- A. Preliminary Plat (PP) No. 16-08/PLN-2016-03522 "Canyon Ranch, Phase 9" proposing to develop approximately 15 acres of land with 43 single-family lots. The site is located at 1500 S. Clodfelter Road. The site is currently zoned Residential, Low Density (RL), the Comprehensive Plan designation is Low Density Residential. The applicant & property owner is Matt Smith, Tri-Cities Development Co. LLC, 15 SW Colorado, Ste. 1, Bend, OR 97702.

COMMUNITY PLANNING DEPARTMENT
STAFF REPORT AND RECOMMENDATION TO
THE HEARING EXAMINER

FILE No: PP 16-08/PLN-2016-03522

Summary of Proposal: A Preliminary Plat proposed to subdivide 15.1 acres into 43 lots.

FIGURE 2

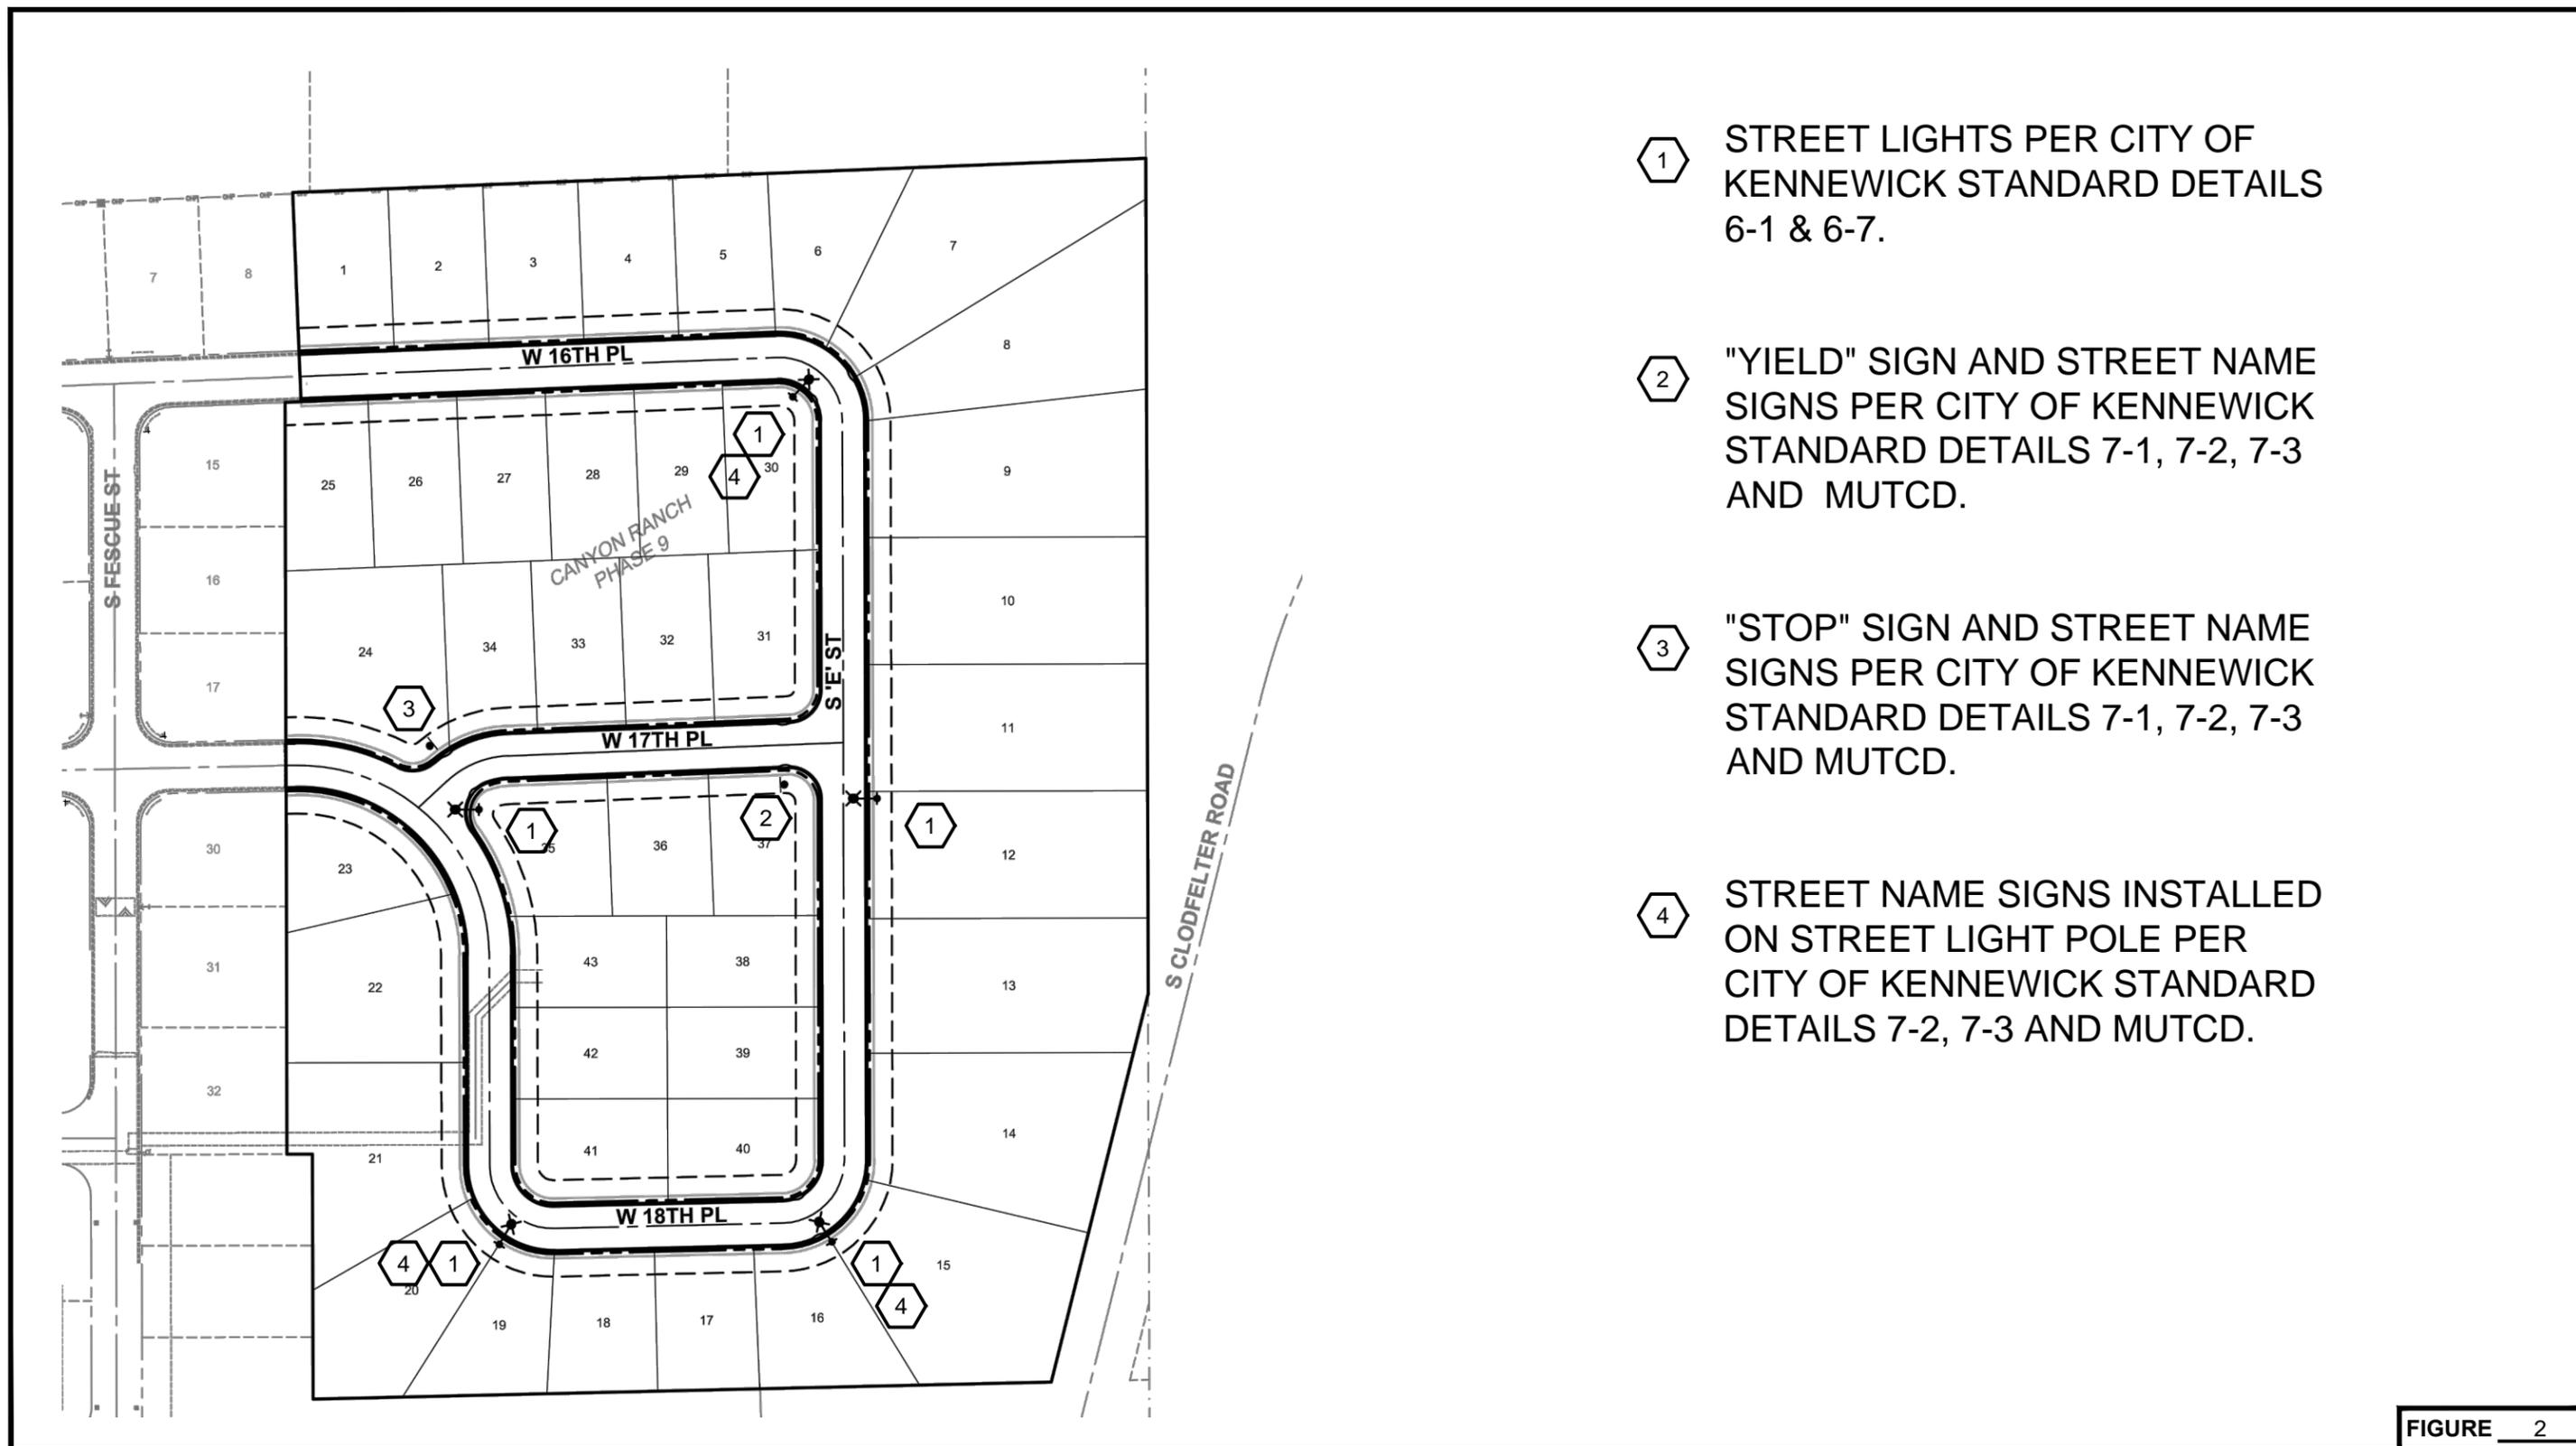
The development will require minimal on-site traffic control. An eastbound YIELD sign is recommended at the West 17th Place/South ‘E’ Street intersection to address the intersection sight distance limitations associated with suburban density housing. At the west end of the proposed West 17th Place segment, a westbound STOP sign is recommended to address the curvature of the continuous roadway. The recommended sign placements are shown on Figure 2.

Street lights are recommended at intersections and other key locations within the proposed development to promote traffic safety. See Figure 2 for proposed locations.

Exhibit 18

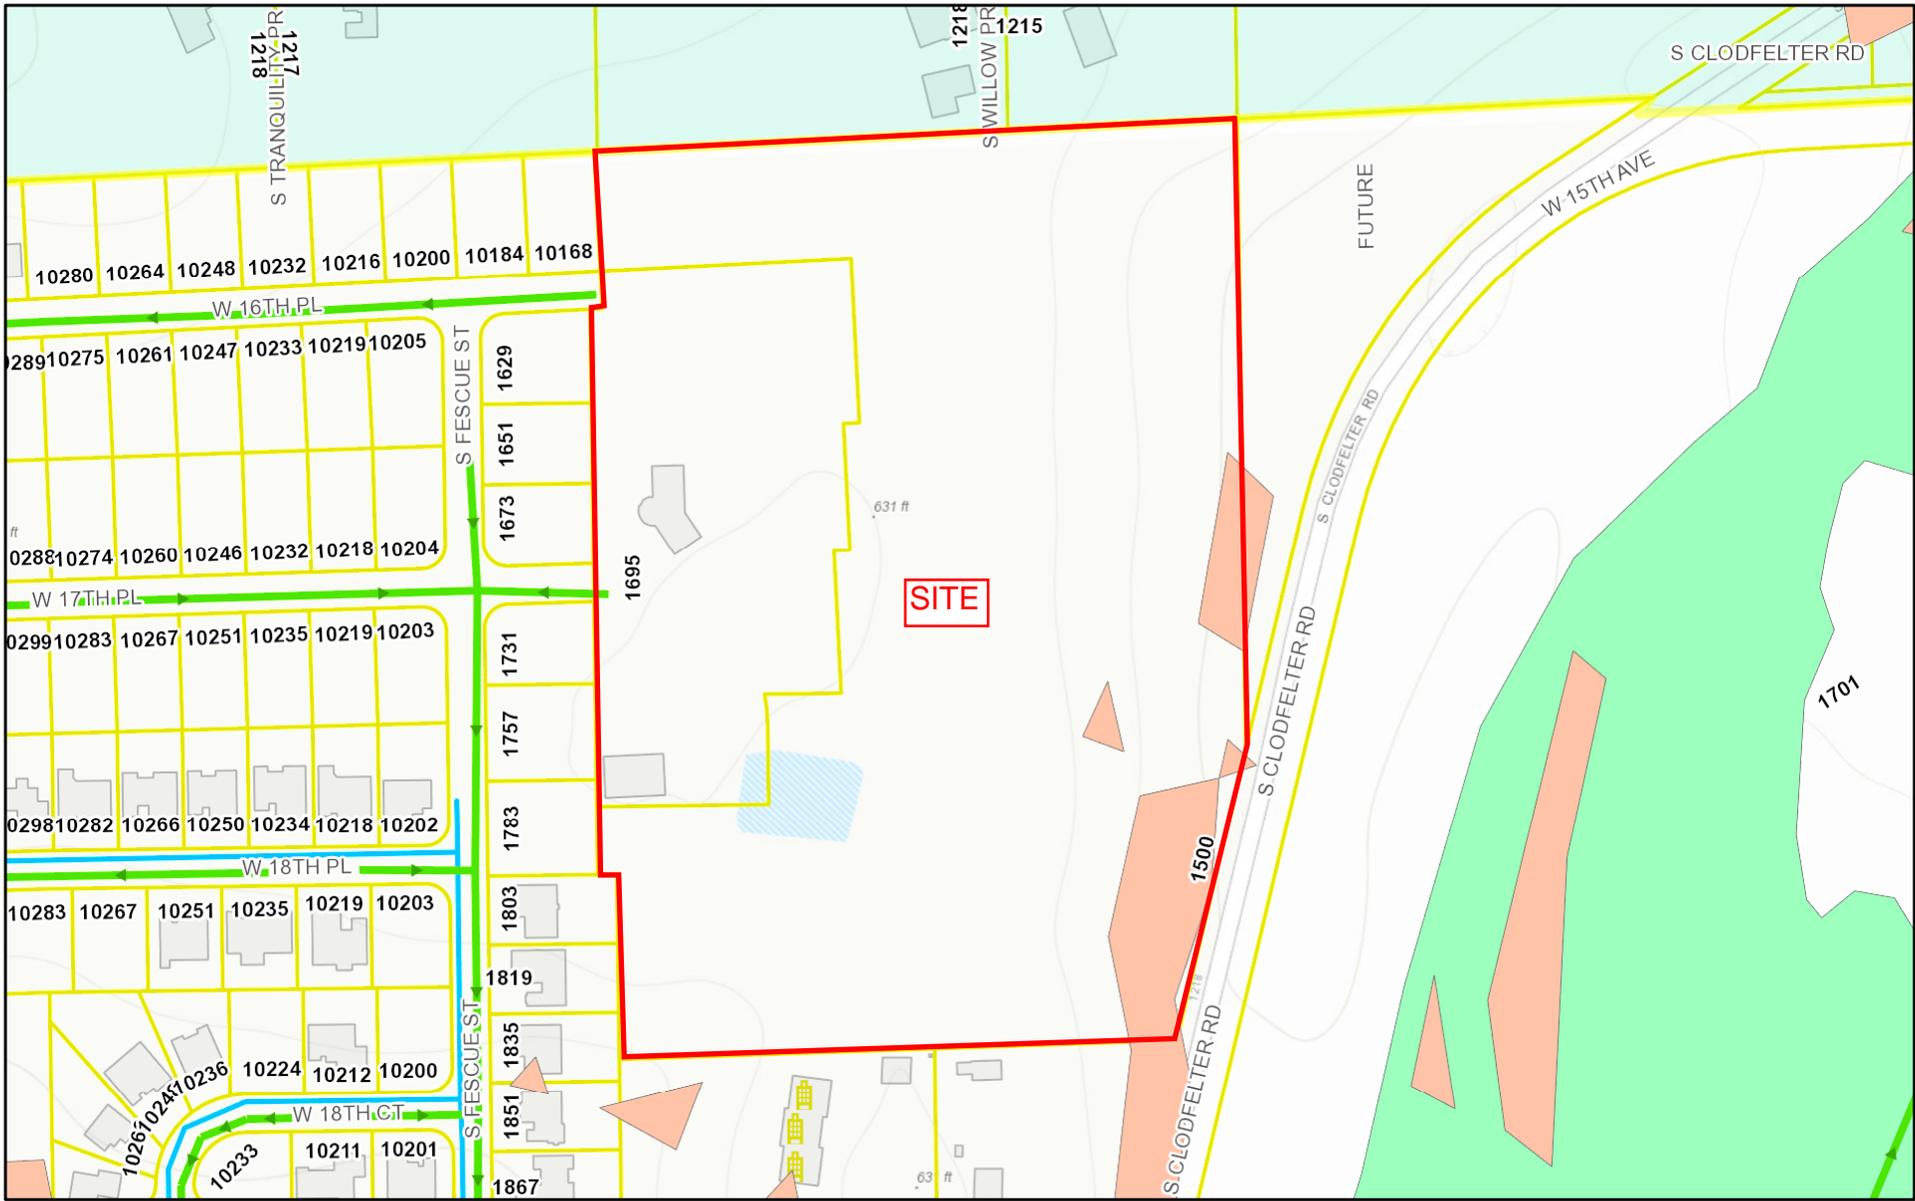
The site does have slopes greater than 15% on the eastern side of the site see Exhibit 18. A Geotechnical Letter was prepared by a Geotechnical Staff Engineer, in the letter the engineer requested to make further recommendations for the project once a grading plan for the project created.

The future development of the site is subject to the requirements of KMC Chapter 18.62 – Geologically Hazardous Areas.
